Clinch River Nuclear Site  
NRC Docket No. 52-047

Subject: Submittal of Supplemental Information Associated with Hydrologic Engineering in Support of the Clinch River Nuclear Site Early Site Permit Application

Supplemental Information Regarding Site Safety Analysis Report Section 2.4,  
“Hydrologic Engineering”

Figure 2.4.3-10. Watts Bar Reservoir Calibration Results - Elevation: 1973 Flood Event

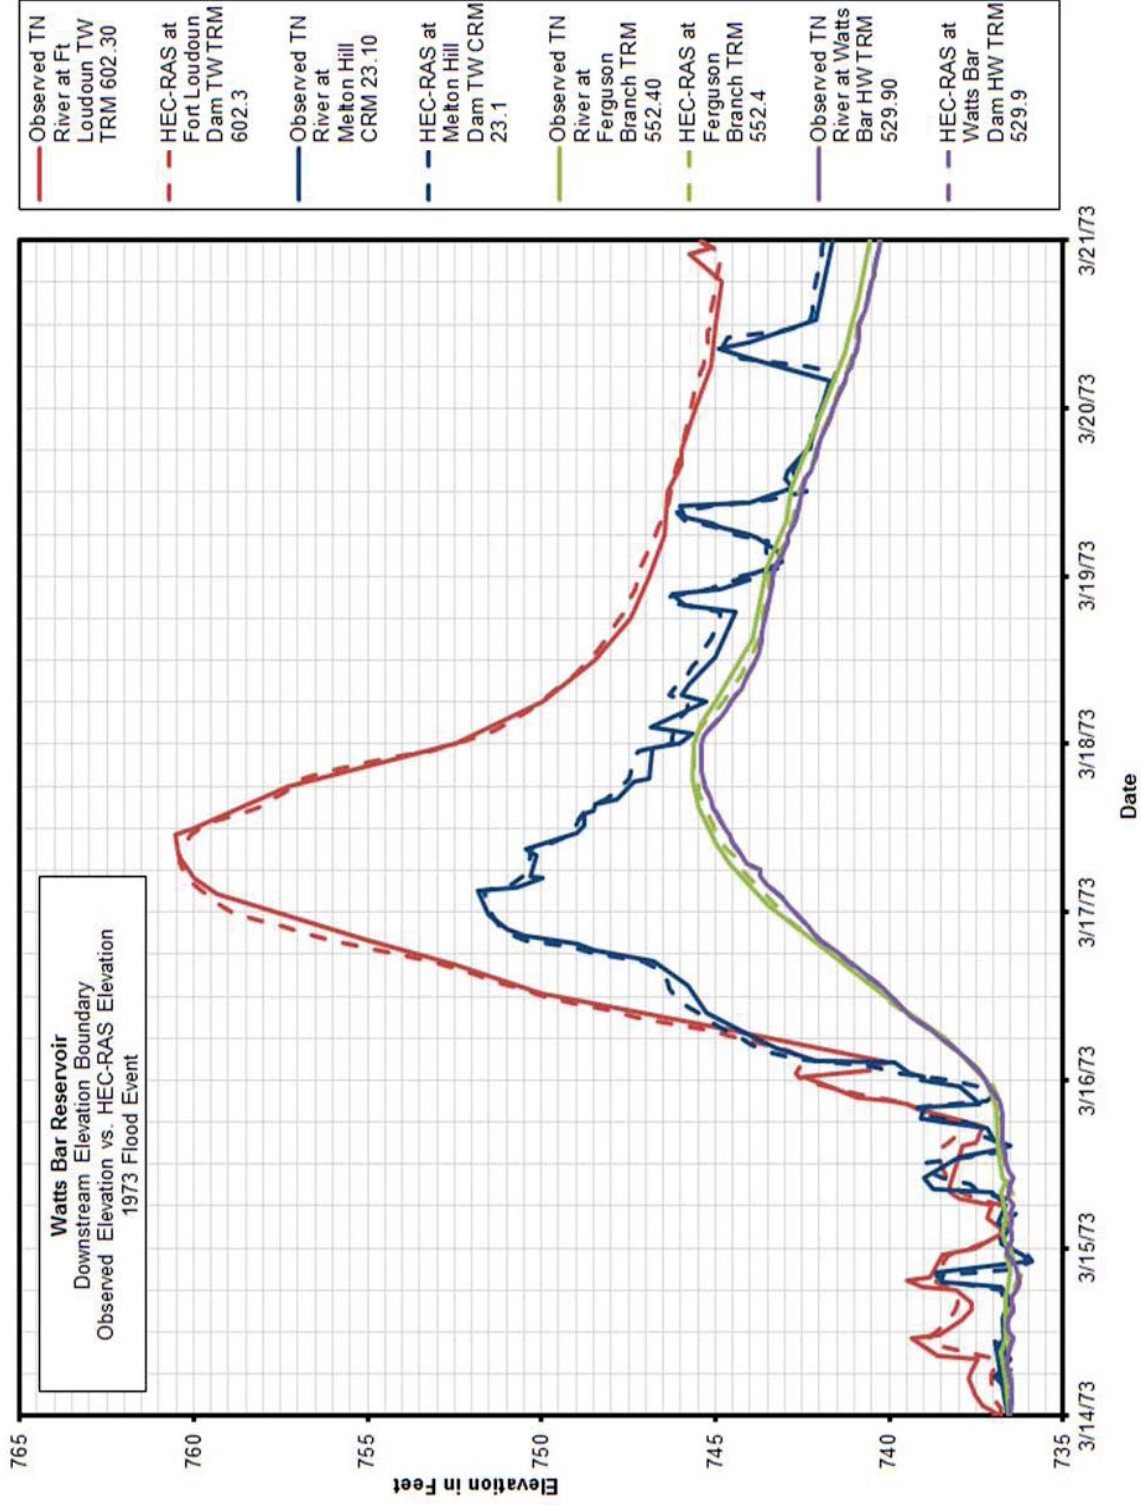
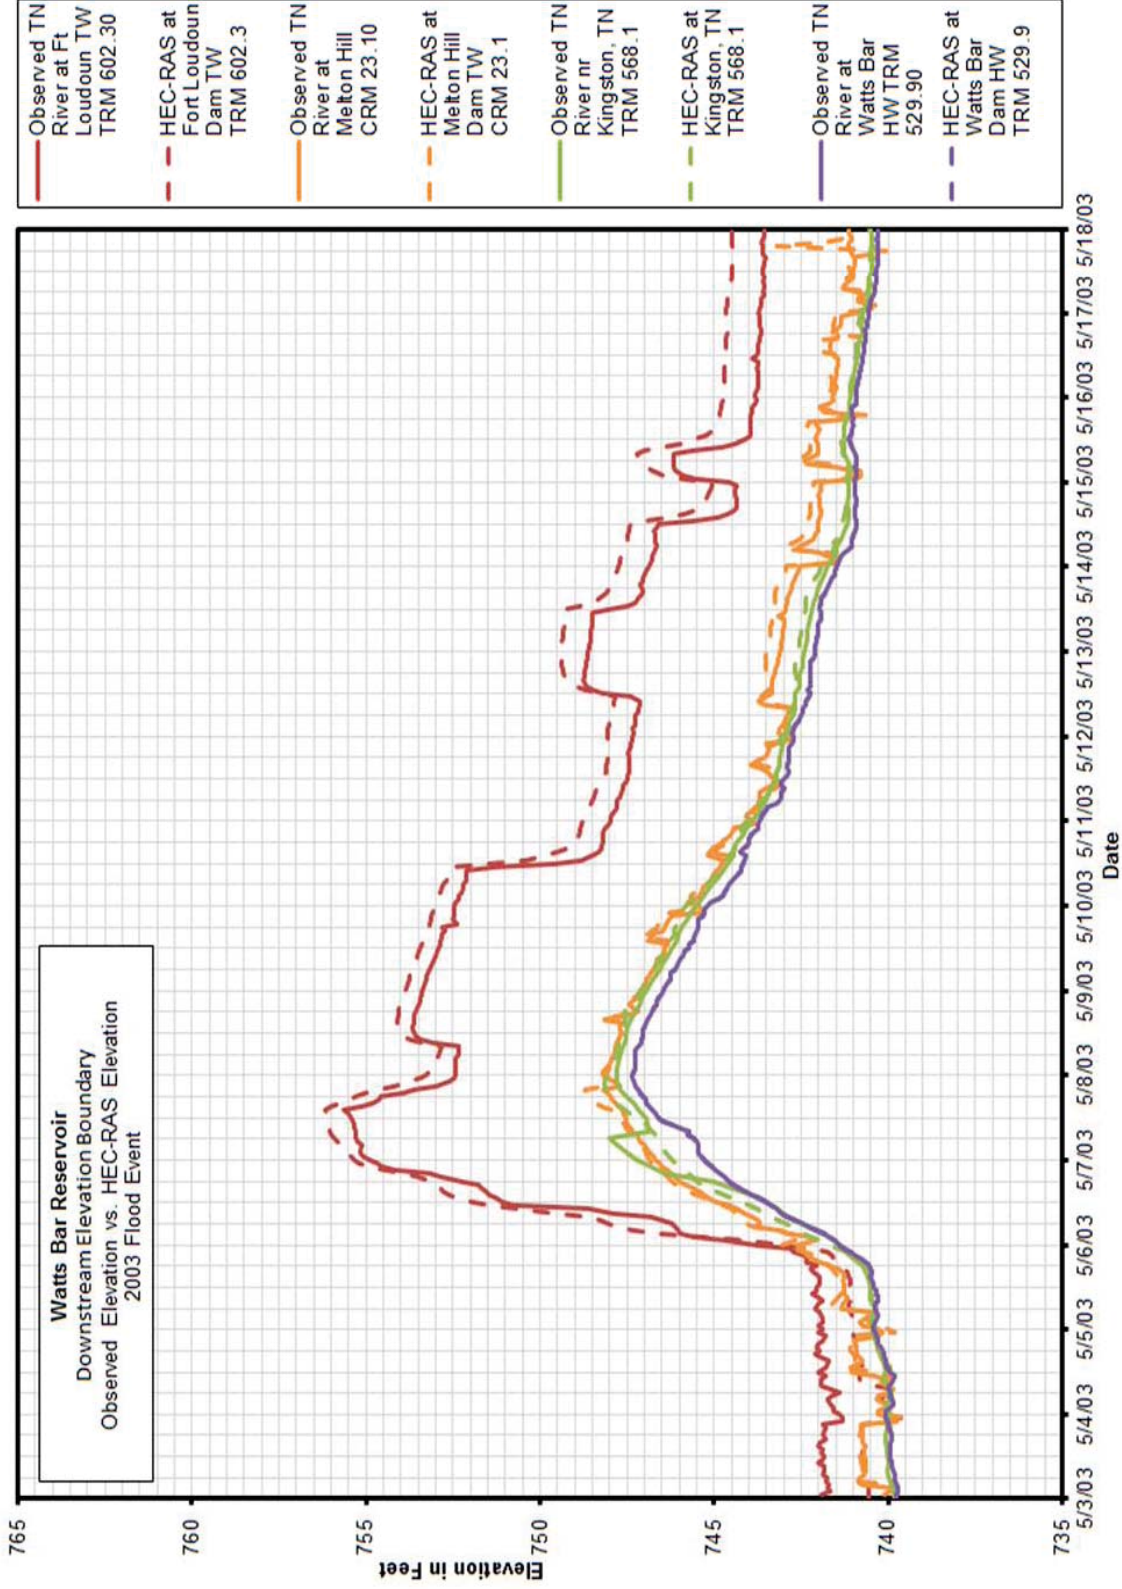
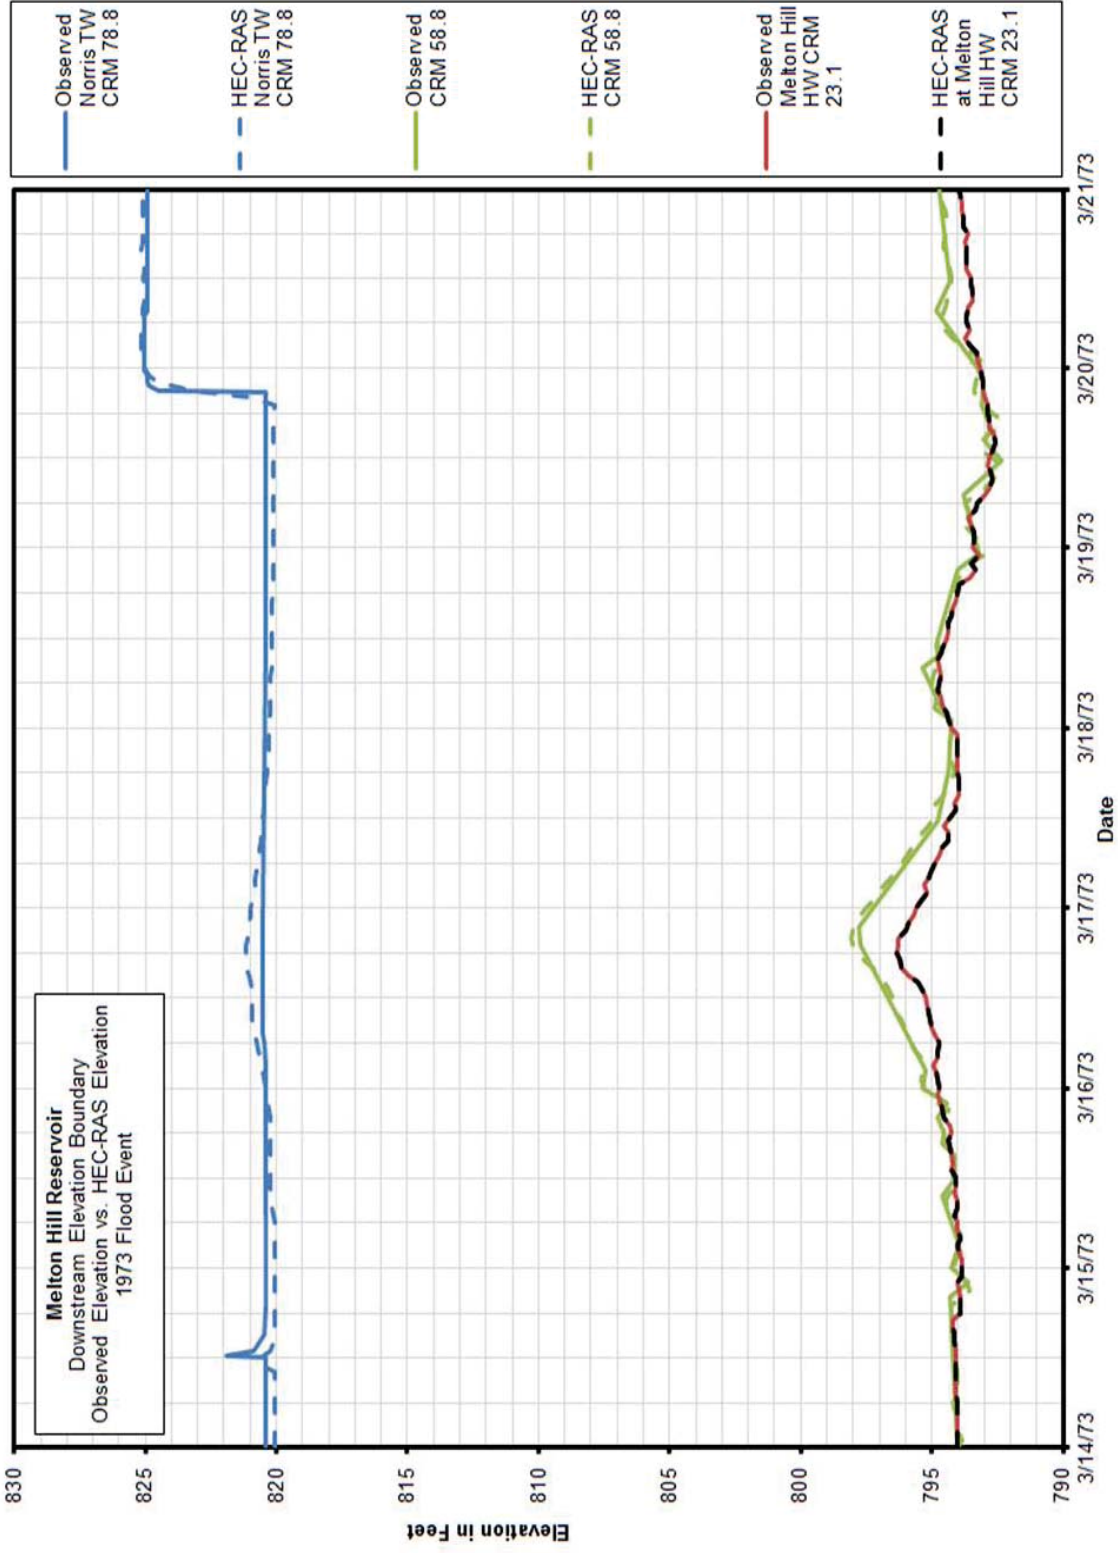
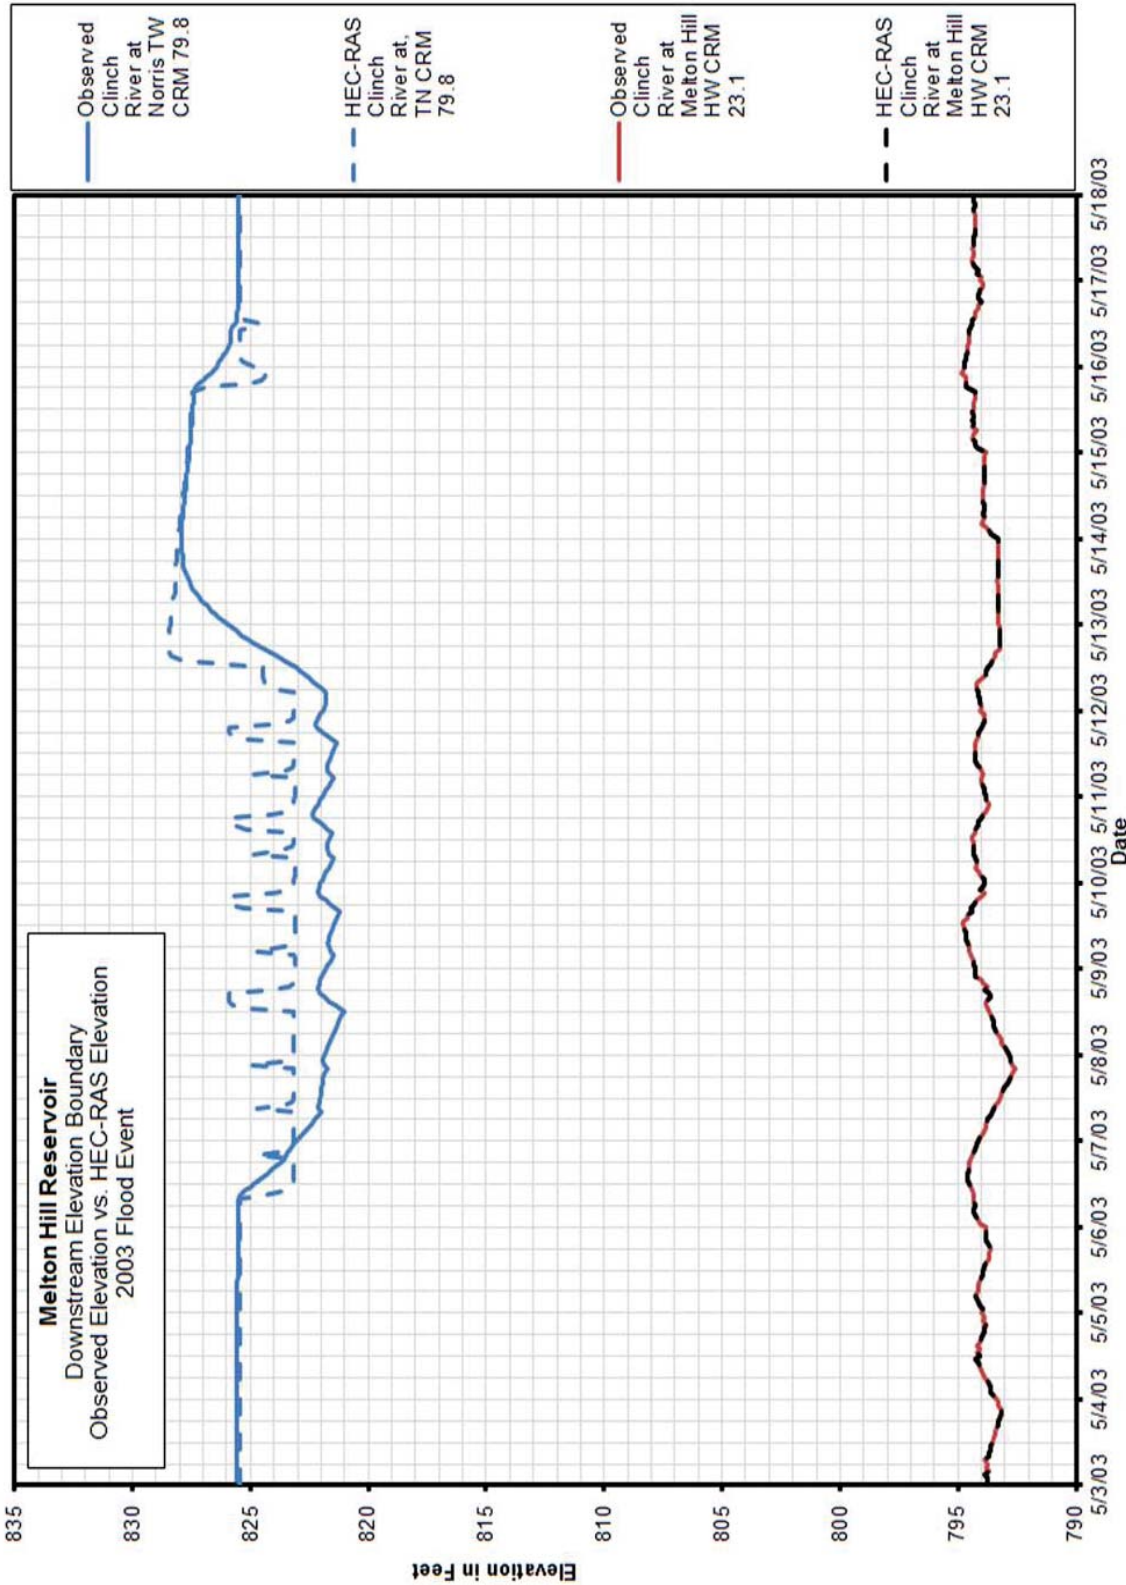
Reference to new Figures 2.4.3-10 through 2.4.3-13, is being added to SSAR Subsection 2.4.3.4.3 to provide calibration points and calibration results for the Watts Bar and Melton Hill Reservoirs. Reference to new Figures 2.4.3-14 and 2.4.3-15 is being added to the SSAR to the calibration point and the calibration result for the Clinch River above Norris Dam. See the markup provided in SSAR Subsection 2.4.3.4.3, ninth, tenth, and eleventh paragraphs, and addition of new Figures 2.4.3-10 through 2.4.3-15 in Attachment 3.

**Figures 2.4.3-10 to 2.4.3-24 are added**

Figure 2.4.3-16. CRN Site Critical Fetch Length

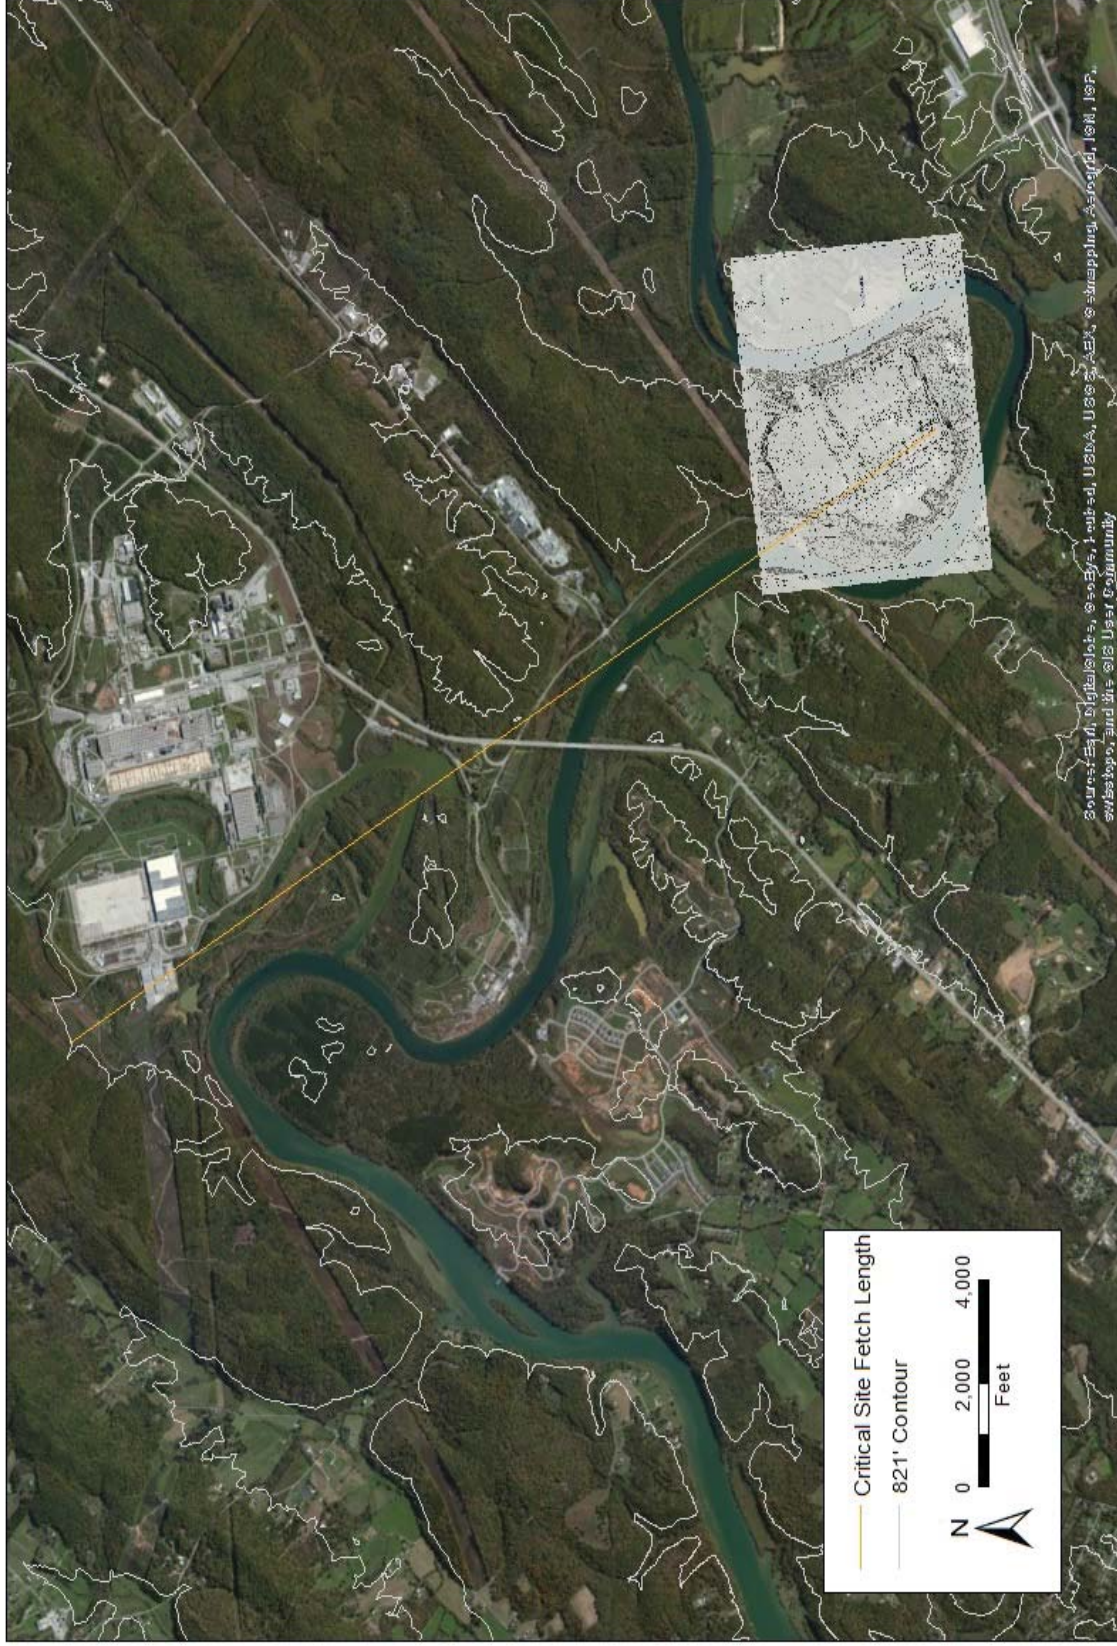
A figure illustrating the PMF elevation in the Clinch River and estimation of the fetch length used in the wind wave calculations is being added to SSAR Subsection 2.4.3.7, "Coincident Wind Wave Activity." See the SSAR Subsection 2.4.3.7 markup and the addition of Figure 2.4.3-16, "CRN Site Critical Fetch Length," in Attachment 3.

A figure illustrating the PMF elevation in the Clinch River and the estimation of the fetch length used in the wind wave calculations is being added to the SSAR. Figure 2.4.3-16, "CRN Site Critical Fetch Length," is being added to SSAR Subsection 2.4.3. Reference to Figure 2.4.3-16 is being added to SSAR Subsection 2.4.4.5, "Coincident Wind Wave." See the addition of Figure 2.4.3-16 in Attachment 3 and SSAR Subsection 2.4.4.5 markup in Attachment 4.
